USNRC APPLICATION
Combined Source and 11e.(2)
Byproduct Material License

*The Reno Creek ISR Project
Campbell County, Wyoming*

**Responses to
Open/Confirmatory Items**

April 2015

PROJECT NO.:	CADD:	CHECKED BY:	APPROVED BY:	PLOT DATE:	FIGURE
2012-250	RRU	RMD			
TYPICAL WELLHEAD DETAILS RENO CREEK ISR PROJECT					7-1

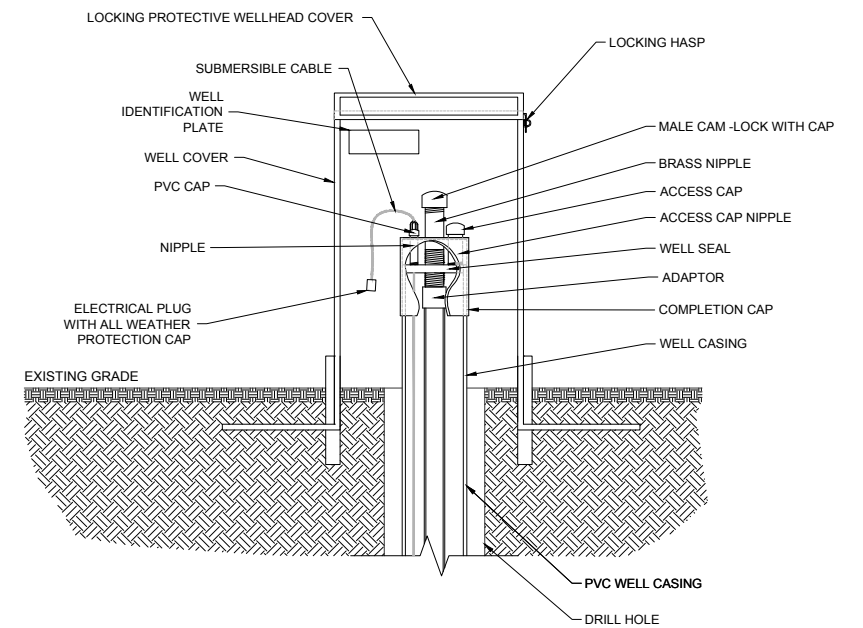
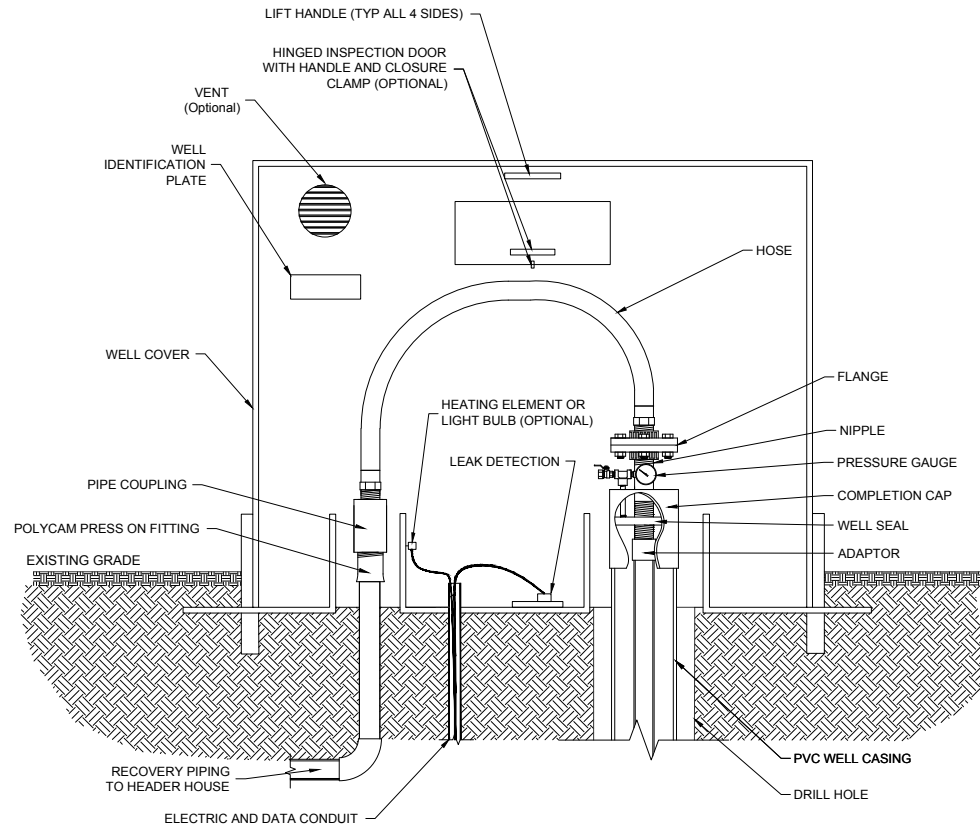
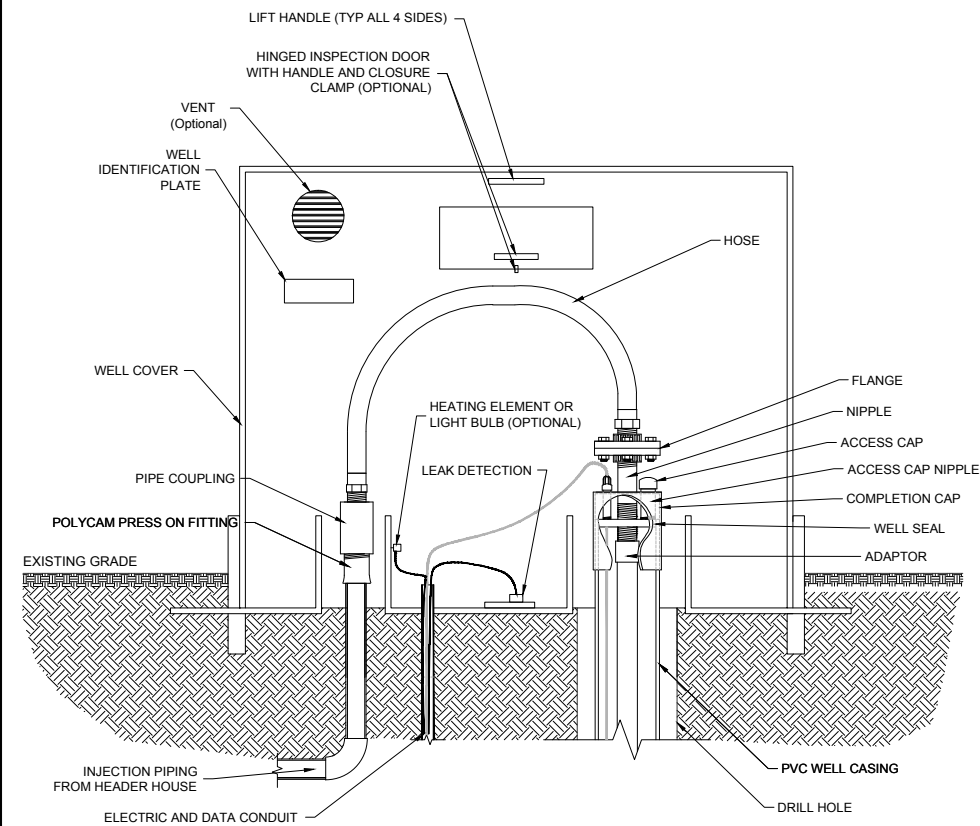
The applicant states that leak detection sensors will be included in the well head sumps but does not include a description of the wellhead completions. The details should discuss protection of the wellhead from accidental damage, freezing from cold temperatures and spills or leaks consistent with guidance in the Standard Review Plan. The wellhead enclosure will have the ability to contain small leaks and incorporate a leak detection system to notify the applicant of a leak before it is released to the environment.

Therefore, staff will require a commitment from the applicant to modify the application to include a diagram which depicts the wellhead completion details.

The following text has been added to TR Section 7.2.5.2 to enhance the discussion on wellhead completions and protection:

- Each wellhead will be covered by a rigid and durable material in order to provide freeze protection and to prevent debris from entering the wellhead area.
- There will be leak containment around the well.
- There will be leak detection at the well heads.
- The opening where the well casing comes up through the bottom of the container will be sealed.
- Each wellhead will be clearly seen and will have an identification label with its unique number indicated on both the wellhead cover and the wellhead itself
- The ground below the spill containment box will be properly stabilized before installing to prevent settling.

The following diagram have been added to TR Section 7 and labeled as Figure 7-1: Typical Wellhead Details.

Proposed Project Schedule

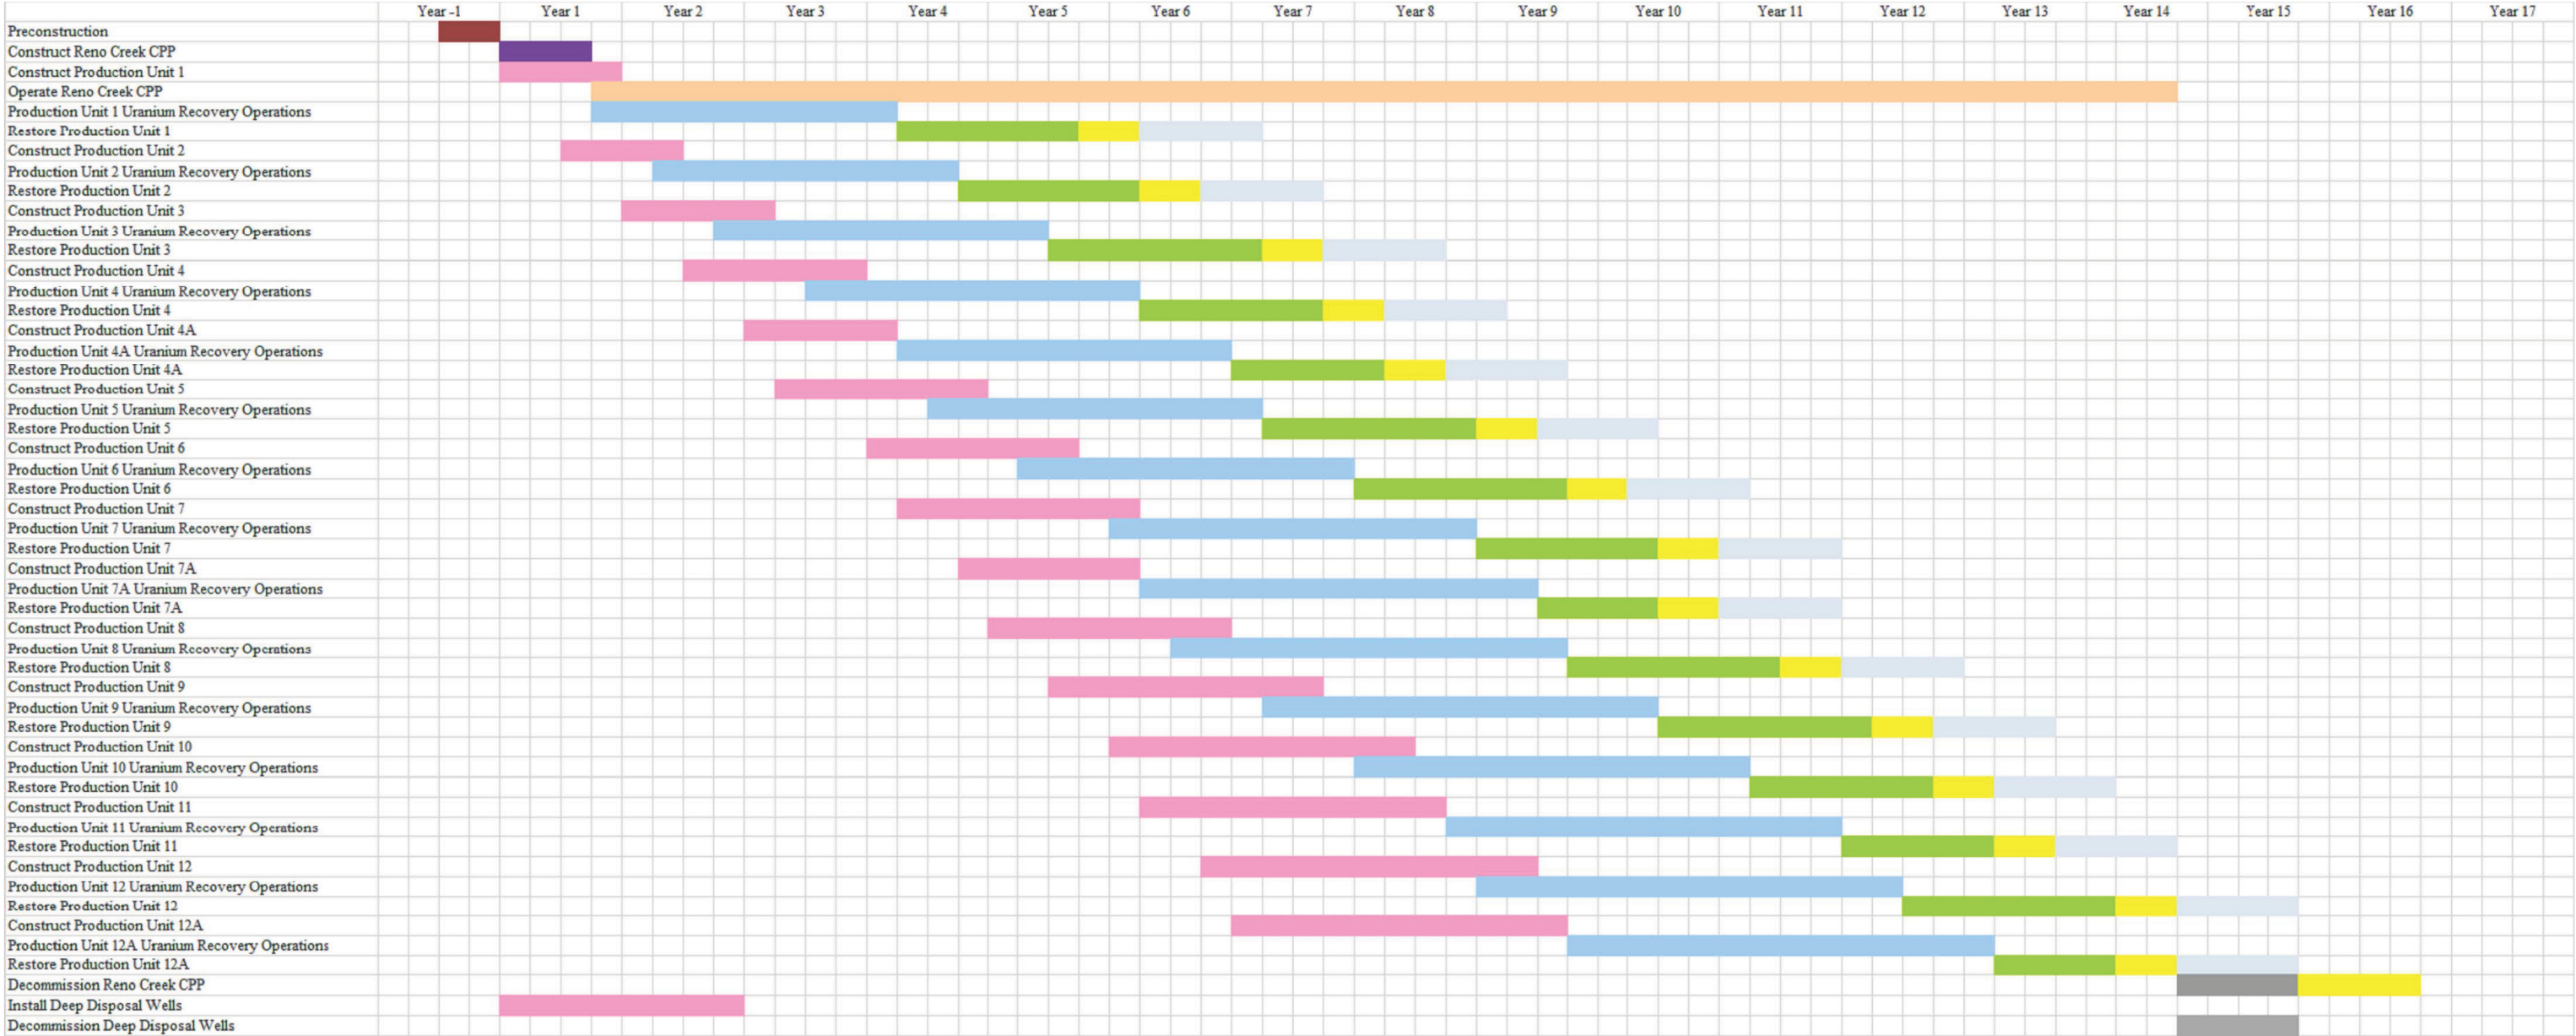
RAI-2 stated if AUC commits to implement a phased decommissioning approach, revise Figure 1-3 (Proposed Project Schedule) to show how the approach affects the start of decommissioning activities, but AUC's revised RAI-2 response but did not include a revised Figure 1-3. Staff notes that AUC's revised RAI response package contains an Appendix F that includes a figure of the Proposed Project Schedule which appears to incorporate a couple changes that do not appear in Figure 1-3 (such as, preconstruction activities prior to installation and construction activities, and changes to the figure legend. The staff requests that AUC commit to ensure Figure 1-3 is consistent with any other Proposed Project Schedule for this application.

4(a) Response

AUC has replaced the original Figure 1-3 in TR Section 1 with the revised Figure 1-3, Proposed Project Schedule. The revised figure is consistent with the figure contained in Appendix F. AUC has also replaced ER Figure 1-6 to ensure consistency for this application.

Figure 5-1: AUC Organizational Chart

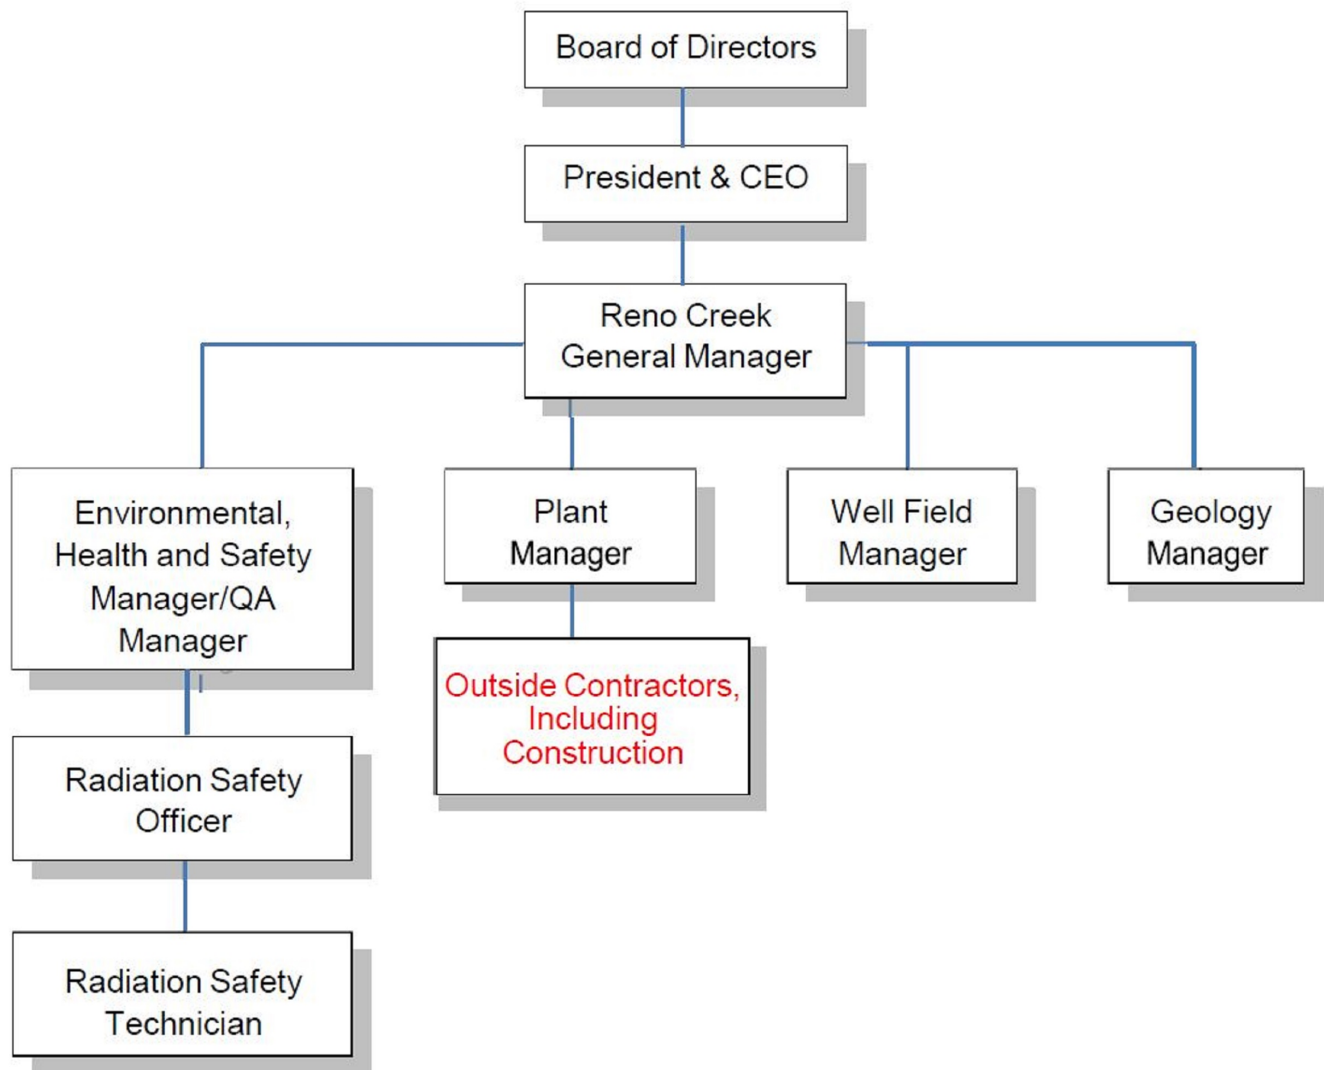
TR Section 5.1 does not address the integration between plant construction and plant management. Also, AUC's Organization Chart in Figure 5-1 shows the Plant Manager position under the General Manager, but it does not show where plant construction and plant maintenance are in the organization. The Standard Review Plan, Section 5.1.3, Acceptance Criteria #2 states "The organizational structure shows integration among groups that support the operation and maintenance of the facility. If the facility is new, integration between plant construction and plant management should be detailed." The staff requests that AUC add clarifying text in the TR to address the integration between plant construction and plant management. Also, clarify the role of the Plant Manager position in Figure 5-1 relative to the integration between plant construction and plant management.

AUC agrees to revise the TR to reflect the modified Figure 5-1, attached below. This figure shows that the Plant Manager is responsible for construction and vendor activities for the Project.

The following text has been added to TR Section 5.1.3:

"The Plant Manager will report to the General Manager. As part of his duties, the Plant Manager will be responsible for construction and vendor activities for the Project."

CPP Facility Controlled Area

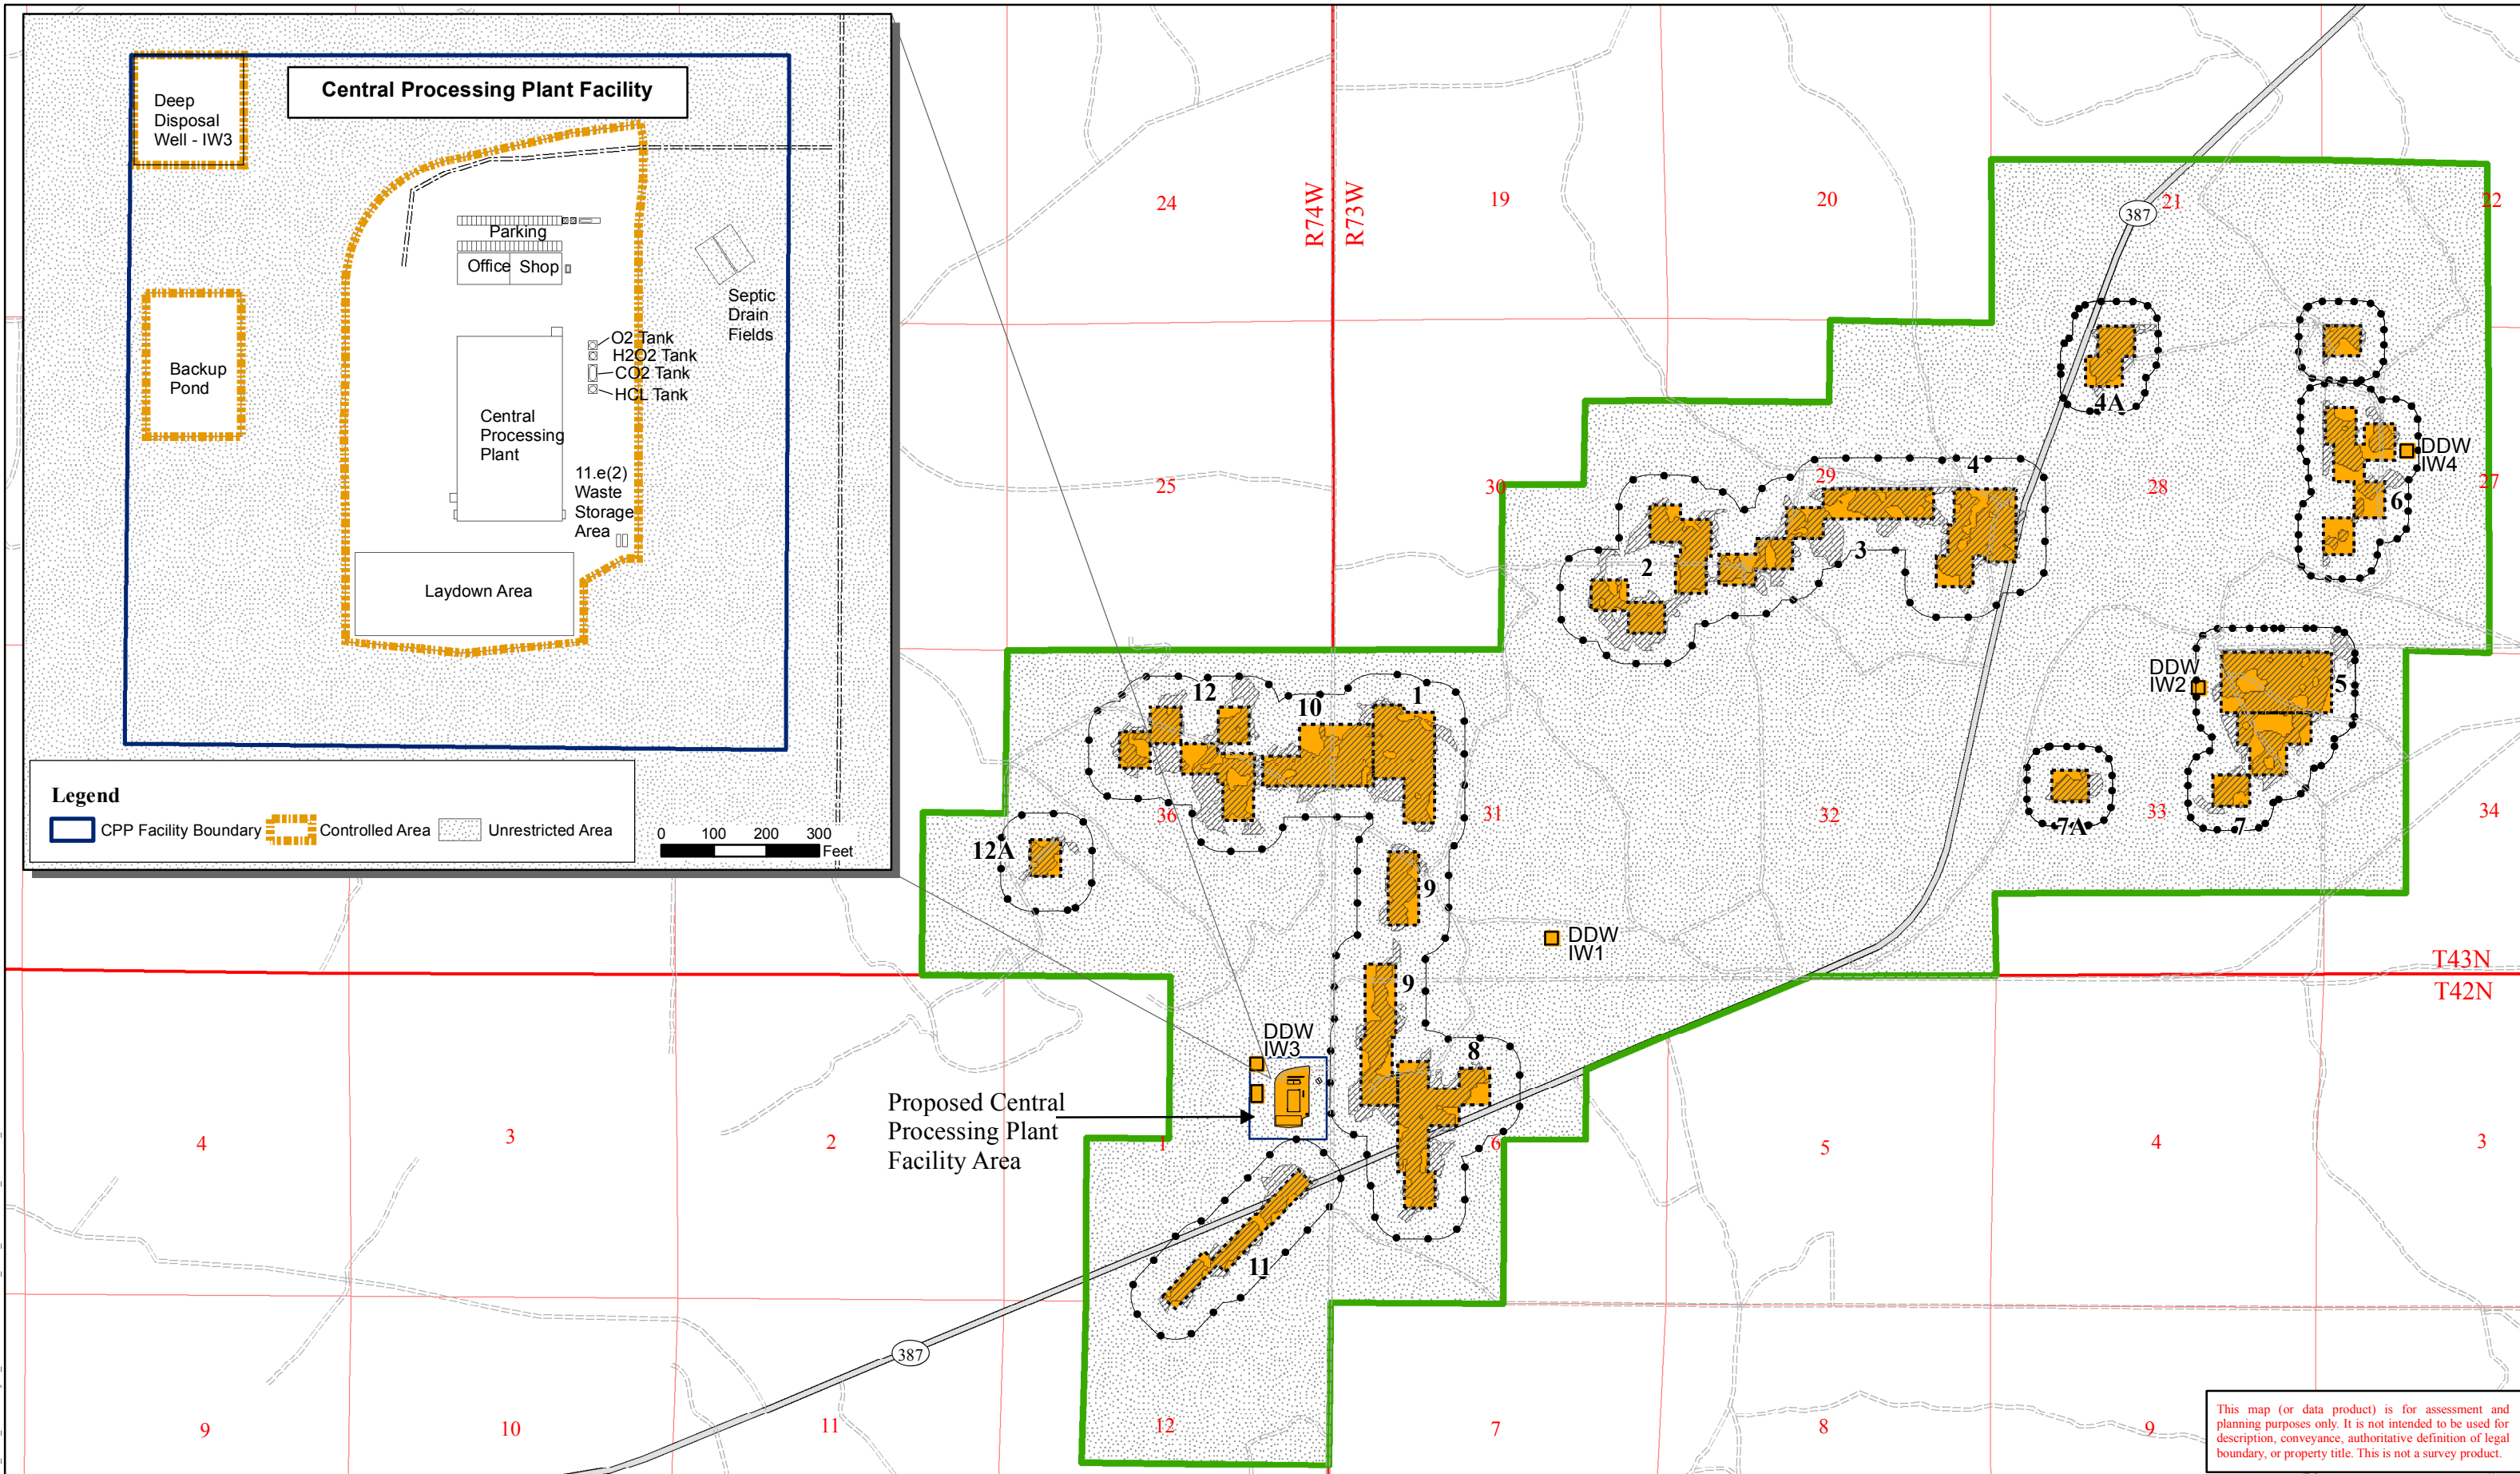
AUC's revised response to RAI-44 added a new Figure 5-2, which shows the controlled area around the CPP. This figure includes an enlarged view of the CPP Facility showing a fenced controlled area that appears to encompass the backup storage pond. However, Figure 3-1 of the TR appears to show the backup storage pond and CPP Facility as 2 separate fenced enclosures. AUC should ensure that the controlled area in Figure 5-2 and Figure 3-1 are consistent.

AUC revised the controlled area in TR Figure 5-2 to be consistent with the controlled area shown in TR Figure 3-1. Figure 3-1 and Figure 5-2 now show identical controlled areas. The newly revised TR Figure 5-2 has been included in TR Section 5 and supersedes the Figure 5-2 shown in the response to RAI-44. The revised Figure is 5-2 is shown below.
